# 1997 - 2002 Corvette: Service Bulletin: Door Rattle with Moderate to High Audio System Volume

**Number:** 01-08-64-009A

**Date:** 06-19-2002

**Subject:** Door Rattle with Moderate to High Audio System Volume

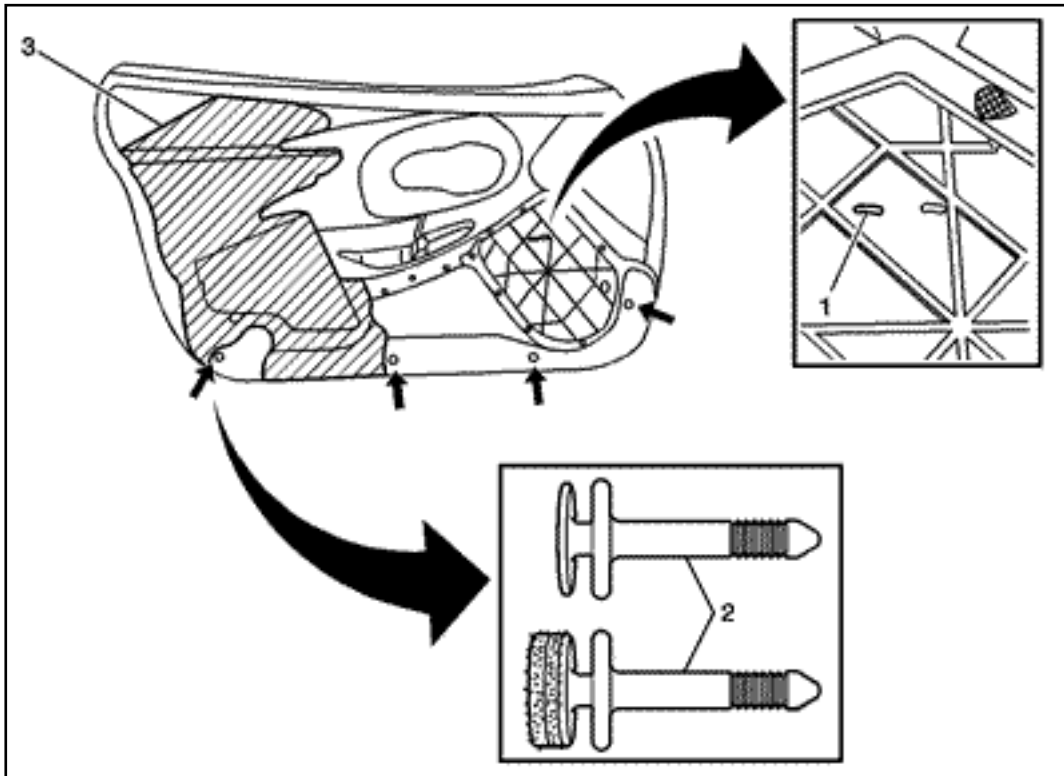
**Change implemented in 2002 VIN breakpoint 125078. Vehicles built prior to this breakpoint will require the following procedure.**

New speaker screen is made from a different material and Bose® emblem is provided due to risk of old emblem becoming damaged while removing.

1. Straighten the speaker grille tabs and remove the grille from the door panel.
2. Remove the Bose® emblem from the speaker grille and discard.
3. Remove the speaker screen from the grille and discard.
4. Install the new speaker screen to the grille.
5. Install the new Bose® emblem and carefully crimp the staples (1) to the speaker grille.
6. Insert the speaker grille tabs into the door panel slots and bend the tabs

to lock the grille in place.

7. Trim any extra loose door panel leather skin from around the speaker grille area on the back side of the door panel.
8. Repeat above steps for opposite side.

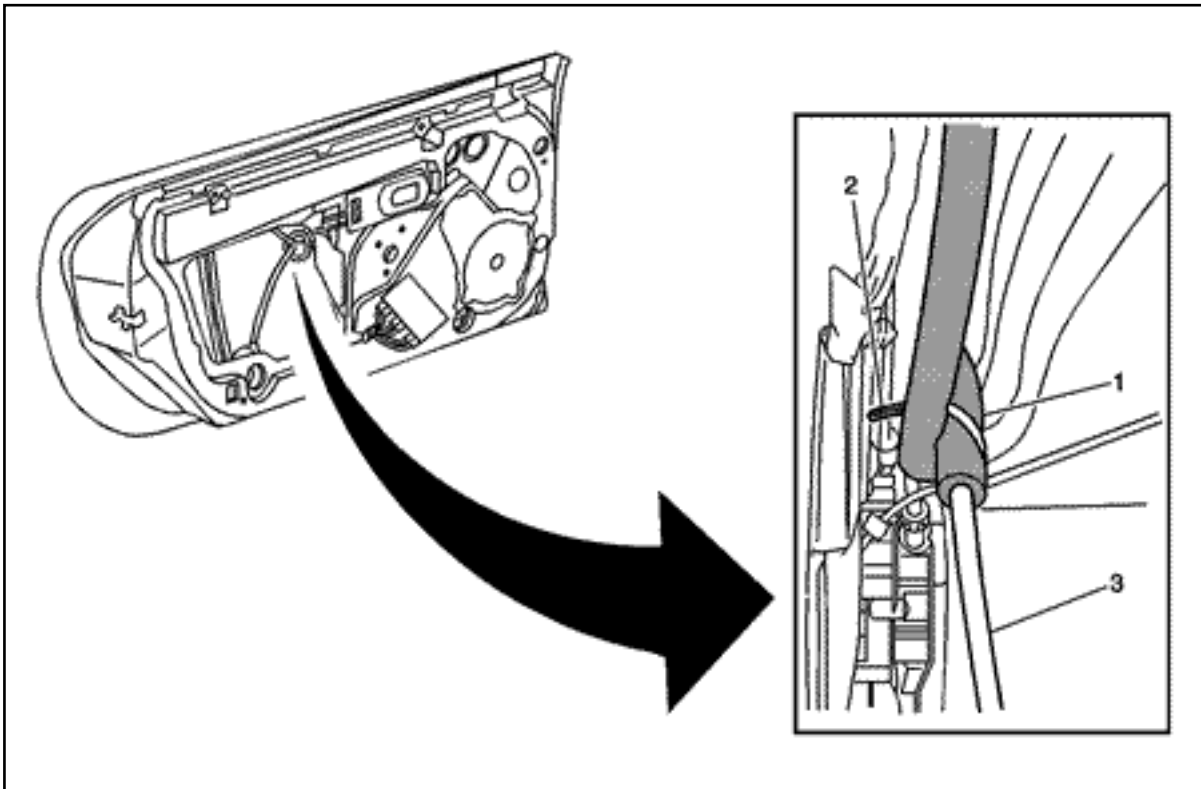
**Change implemented in 2001 VIN breakpoint 115500. Vehicles built prior to this breakpoint will require the following procedure.**

1. Remove the 4 lower door trim panel retainers (2) from both door panels.
2. Cut 16 dime sized coins from the fine side of Velcro®, 3M® P/N 051131-06481, or equivalent.
3. Install 2 Velcro® coins to each of the 8 door trim panel retainers (2).
4. Reinstall the door trim panel retainers (2) into the door trim panels.

**Change implemented in 2000 VIN breakpoint 110900. Vehicles built prior to this breakpoint will require the following procedure.**

1. Only perform the following procedure if the side impact styrofoam (3) is loose from the door panels.
2. Resecure the side impact foam (3) to the door trim panels using 3M® Urethane, P/N 051135-08690, or equivalent.

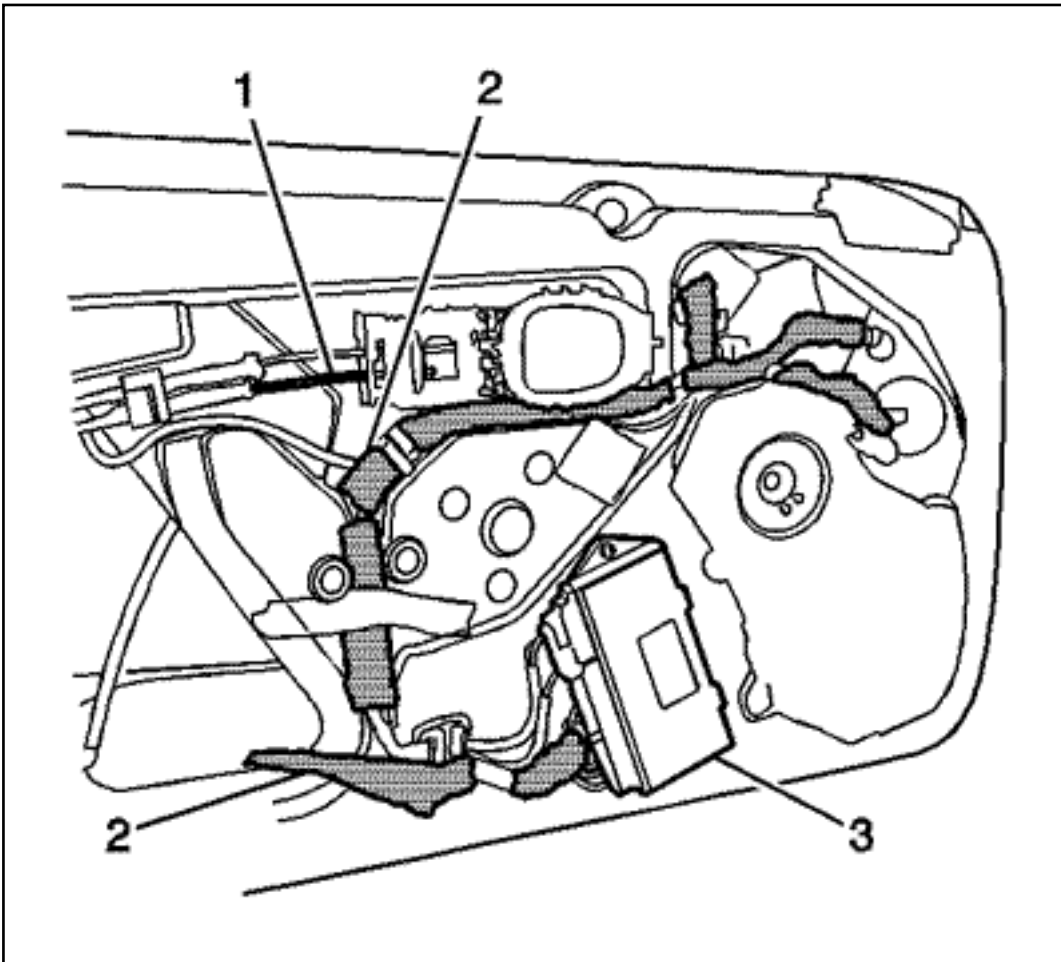
**Change implemented in 1999 VIN breakpoint 133100. Vehicles built prior to this breakpoint will require the following procedure.**

1. Remove the water deflector.

**Do not damage the push-in retainer/tie straps (2). They are to be reused.**

2. Remove the push-in retainer/tie straps (2) that retain the window regulator cables (3) to the inner door panels.
3. Reposition the push-in retainer/tie straps (2) out of the way.
4. Add 122 mm (5 in) of 3M® Open Cell Interior Foam Tape (1), P/N 051131-62385, or equivalent, to the window regulator cables (3) where they contact each other and the inner door panels.

5. Reinstall the push-in retainer/tie straps (2).
6. Reinstall the water deflector.

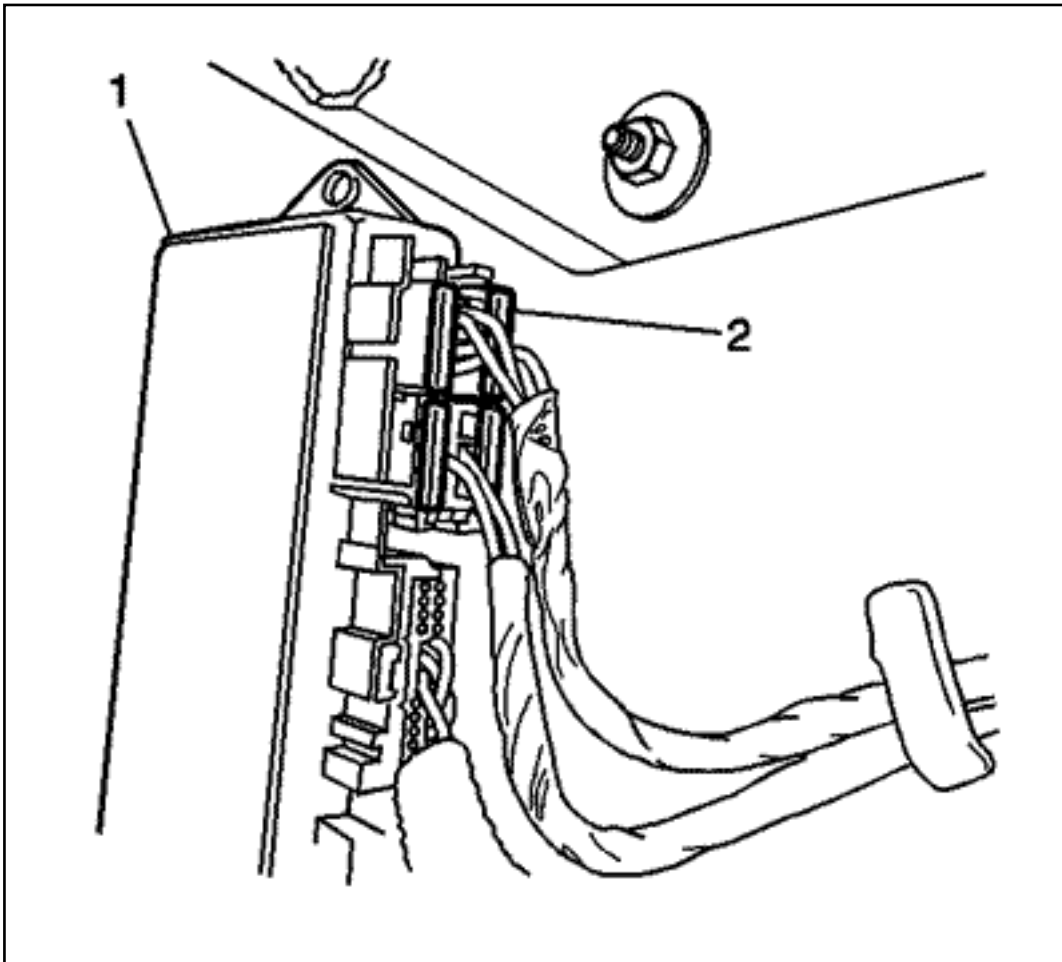
**Change implemented in 2000 VIN breakpoint 101578. Vehicles built prior to this breakpoint will require the following procedure.**

1. Remove the wire harness (2) from its retainers.
2. Insulate the wiring harness and in-line connectors (2) where the wiring harness and the in-line connectors (2) contact the door with 3M® Open Cell Interior Foam Tape (2), P/N 051131-62385, or equivalent. It is best to insulate the entire wiring harness (2).
3. Insulate the right door speaker connector with P/N 12378189.

**Change implemented in 2000 VIN breakpoint 123000. Vehicles built prior to this breakpoint will require the following procedure.**

1. Remove the screws attaching the door control modules (3).
2. Add felt, P/N 12378189, to the backside of the door control modules (3) where it contacts the inner door panels.
3. Position the door control modules (3) to the doors.
4. Install the screws attaching the modules (3). **Tighten**

Tighten the door control modules (3) attaching screws to 3 N·m (27 lb in).

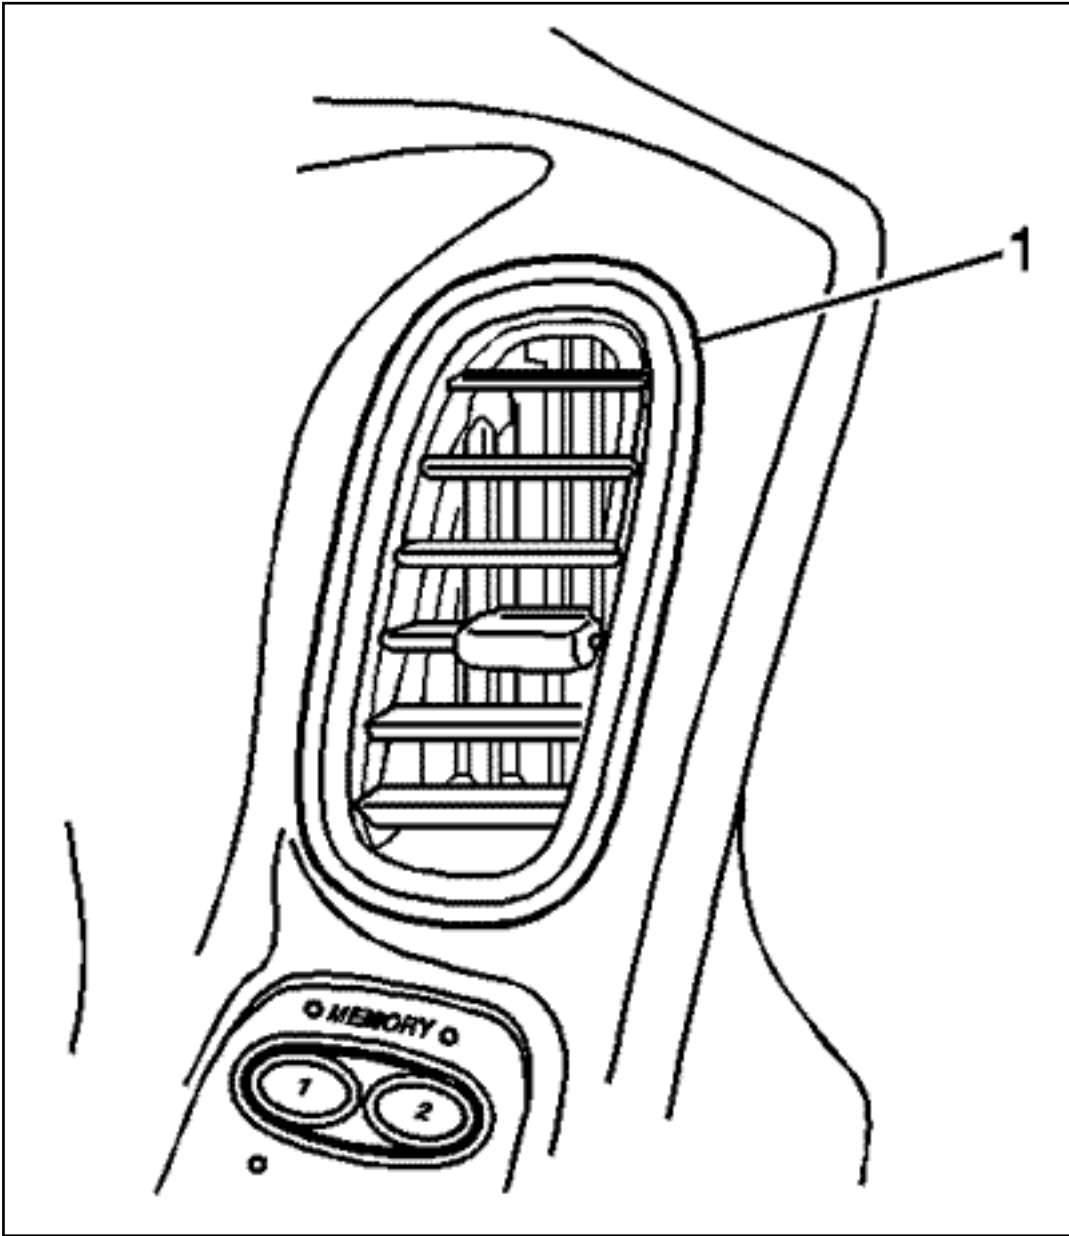
**Change implemented in 2000 VIN breakpoint 120397. Vehicles built prior to this breakpoint will require the following procedure.**

Add a small piece of duct tape, 3M® P/N 051131-06969, or equivalent, to the door control modules (1) terminal positive assurance (TPA)'s (2). They are grey in color and there are a total of 4 TPA's (2) per door. If the TPA's (2) are blue, they are the new design and do not need to be taped.
